Project No. 07-1122-0277

**PROVISION OF INFORMATION
CATEGORY 3 PERMIT TO TAKE WATER APPLICATION
FUTURE STAGES OF FINDLAY CREEK VILAGE SUBDIVISION
OTTAWA, ONTARIO
MOE REFERENCE # 4635-7GFNDT**

PROJECT
FINDLAY CREEK VILLAGE - FUTURE STAGES
 PTTW APPLICATION

TITLE
SITE PLAN

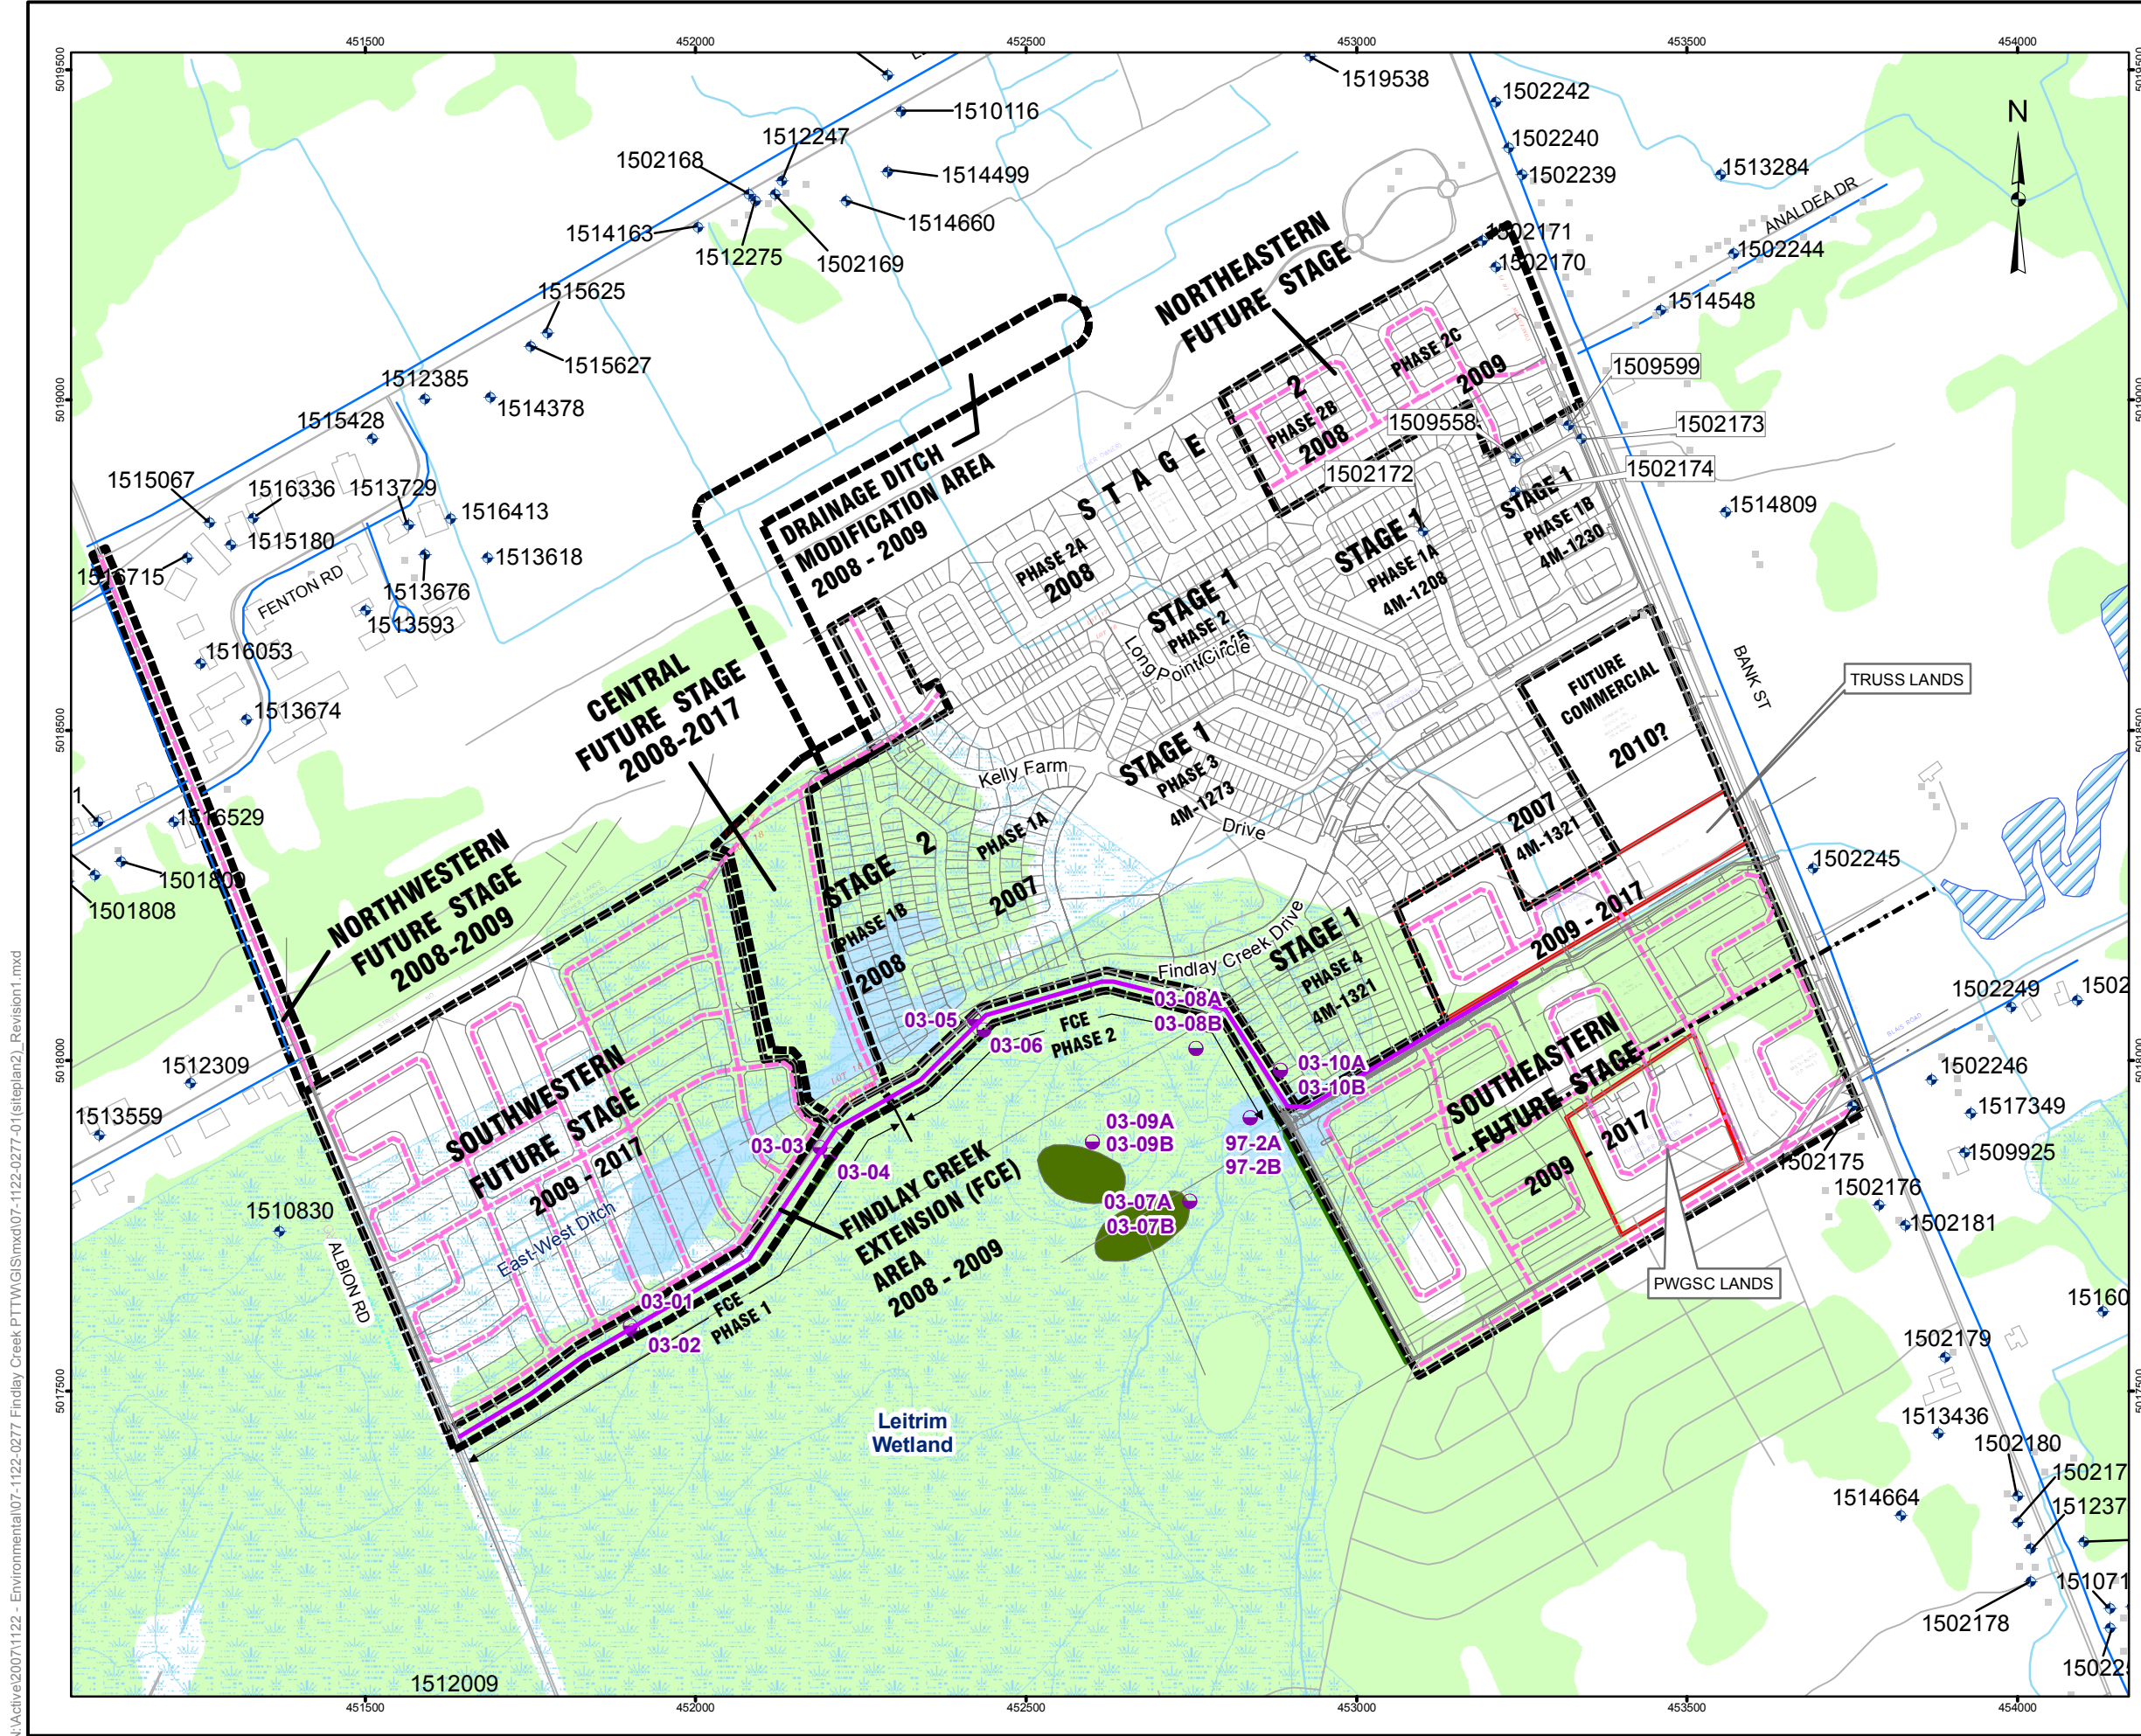
The Attached Figure 1, Revision 1 is an update to Figure 1 provided in the Application Document. The revised Figure adds two areas to be covered by the PTTW: 1) the Findlay Creek Extension (FCE) Area along the north and east sides of the Leitrim Wetland and 2) the Drainage Ditch Modification Area to the north of the central portion of the actual property.

The FCE is a relatively shallow ditch (about 1 to 1.5 m deep) to convey surface water from west of Albion Road across the subdivision property and outlet to Findlay Creek; this feature will replace the East-West ditch located about 200 m further north. As a DFO Authorization, fish habitat compensation measures are being constructed within the FCE. As shown, the FCE is divided into two phases, Phase 1 being the western portion and Phase 2 being the eastern portion. Phase 1 construction is nearly complete; temporary management of surface water flowing towards the construction area is accomplished under PTTW 1832-7G8K GK which expires November 30,

2008. Phase 2 is presently occupied by a temporary bypass ditch; which needs to be replaced by the construction of the FCE along the same alignment. In order to complete the construction of Phase 2, and possibly to complete a portion of Phase 1 in order to put it into service, it will be necessary to temporarily intercept water and/or divert surface water in order that work can be carried out in the dry, both for excavation and shaping purposes, for placement of hydric soils and installation of habitat compensation features and so vegetation can get established before the FCE can be placed into service. The intercepted/diverted water will be mostly conveyed into the storm sewer and sent to the stormwater management pond east of Bank Street for treatment. However, in order to maintain base flow in Findlay Creek for purpose of maintaining fish habitat conditions, a portion of the intercepted/diverted water will have to be returned to Findlay Creek (without entering the sewer). It may also be necessary at some points in the construction for the water to be pumped to a temporary sedimentation pond(s) such that its quality is acceptable to be discharged to Findlay Creek. The quantity of water to be returned to the creek will vary in order to mimic seasonal base flow rates; based on previous baseflow measurements, it is expected that this will typically be of the order of 40 to 60 Lps. It is expected at this time that work on the Phase 1 portion of the FCE will be mostly complete by the end of 2008 and that the Phase 2 work will be carried out after July 1, 2009. As per discussions with DFO, it is planned to have the entire length of the FCE in service by the end of 2009, and potentially to have the Phase 1 section commissioned by the end of 2008.

Work is required in the Drainage Ditch Modification Area to effect some changes to the existing ditch network in order that surface water originating north of the development area can be conveyed into the new North-South Ditch (a replacement for the existing North-South ditch which is on the same alignment) to be constructed along the east side of the Central Future Stage (park land) and then into Findlay Creek. The ditch modifications consist of short sections of new ditch and some ditch improvements. In order to construct these new ditches, and to construct the new North-South ditch, it will be necessary to temporarily divert surface water around work areas and into downstream sections of ditch and/or intercept the surface water and convey it by either ditching or pumping it into the storm sewer system and to the stormwater management pond east of Bank Street for treatment.

1	Additional Future Stage Areas	28 Aug. 2008
REV.	DESCRIPTION	DATE
